Access Compliance Report

Public Rights-of-Way

(Curb Ramps)

Intersection ID: 28066	Main Street: LANDEN_DR	Cross Street: OLD_SOUTH_CT	Location: SE
ADA ID: 7BD647962D34	Ramp Type: PerpDiag	Initial Pass/Fail: Fail	Overall Compliance: No
			Severity Score: 58.75

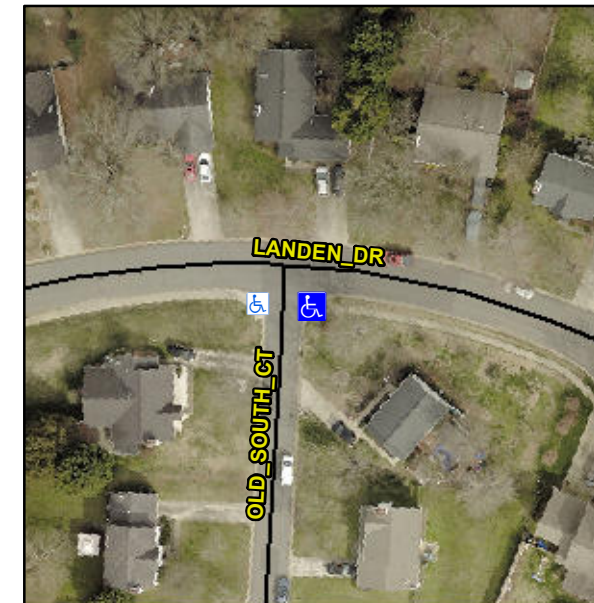
Not Found, R304.5.1, R304.2.2, R304.5.3

Compliance	Description	Data	Compliance	Description	Data
N/A	Ramp Length (in)	92.0	No	Ramp Slope (%)	12.3
No	Ramp Width (in)	43.0	No	Ramp XSlope (%)	7.9
N/A	Flare Type LT	N/A	N/A	Flare Type RT	N/A
N/A	Flare Slope LT (%)	N/A	N/A	Flare Slope RT (%)	N/A
N/A	Flare Traversable LT?	N/A	N/A	Flare Traversable RT?	N/A
N/A	Landing Length (in)	N/A	N/A	DWS Provided?	N/A
N/A	Landing Width (in)	N/A	N/A	DWS Contrast?	N/A
N/A	Landing Slope (%)	N/A	N/A	DWS Length (in)	N/A
N/A	Landing X Slope (%)	N/A	N/A	DWS Full Width?	N/A
N/A	Landing Curb? (Y/N)	N/A	N/A	DWS Offset (in)	N/A
N/A	Shared Landing?	N/A			
N/A	Gutter Ponding?	N/A	N/A	Gutter Slope (%)	N/A
N/A	Gutter Lip Ht (in)	1.0	N/A	Gutter X Slope (%)	N/A
N/A	Painted X Walk1?	No	N/A	Painted X Walk2?	No
	X Walk 1 Direction	To NE		X Walk 2 Direction	To NW
N/A	X Walk 1 Width (in)	N/A	N/A	X Walk 2 Width (in)	N/A
	X Walk 1 Slope (%)	2.9		X Walk 2 Slope (%)	3.3
	X Walk 1 X Slope (%)	2.1		X Walk 2 X Slope (%)	2.4

Remove & Replace Curb Ramp With Two New Directional Ramps or Equivalent.
